7 February 2012

**Proposed Modification to Approved Major Project No. 09\_0051 – Centre for Obesity, Diabetes & Cardiovascular Disease**

COMPARATIVE VIEW CORRIDORS DIAGRAM

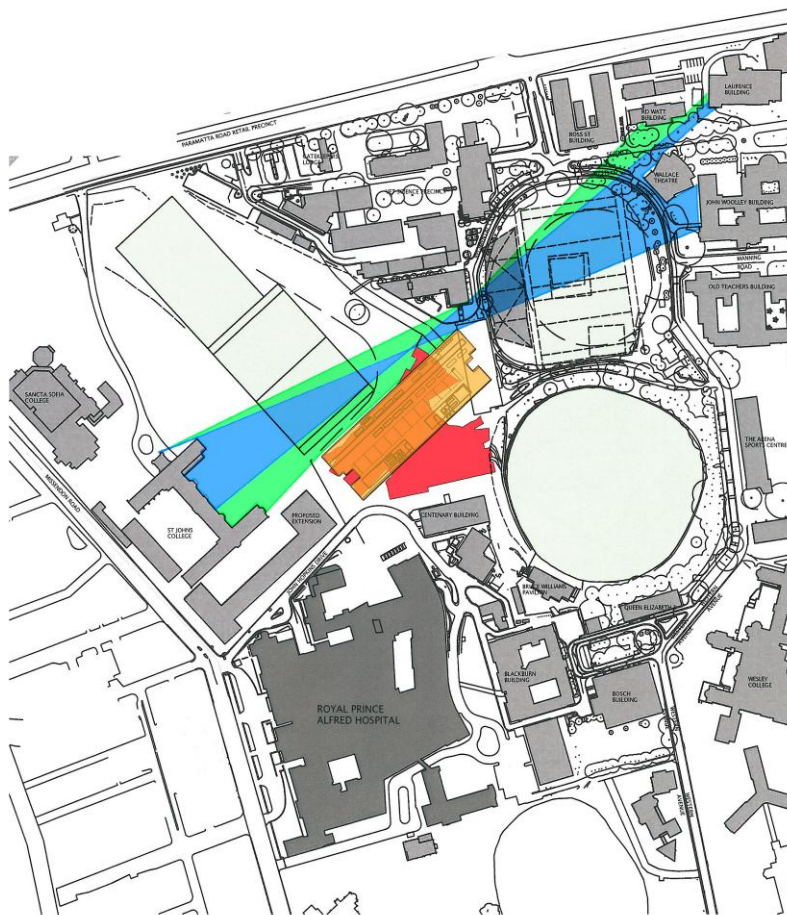
*Proposed alignments relative to St John's College and the view corridor*

- The proposed northern alignment is sited south of the approved scheme's floor plate, where it projects into the north-east view corridor as illustrated in the diagram below. The proposed northern alignment is 11.8m south of the north – eastern corner of the approved scheme from Level 2 to roof level. Proposed Level 1 is also setback a further 1.1m south in this location.

- The proposed north-western corner area of Level 1 is approximately 900mm south of the approved north-western corner.
  - Level 2 has been amended from the submitted scheme to include a setback of 1.1m in the north-western corner along the northern façade to follow the alignment of Level 1 below. This contributes towards opening up the view corridor to the north-east at the ground plane, in conjunction with the inclusion of glazing to Level 2.

- The upper levels, up to the parapet in the north-western corner and along the northern face of the proposed building are aligned with the centre line of the St John's College Southern Annex. In conjunction with the significant setback of the proposed north – eastern corner relative to the approved scheme, from Level 1 to roof level, the result is a positive gain. As illustrated in the diagram below, it is evident that the views to and from St John's College in the north-east primary view corridor is widened in comparison to the approved scheme.
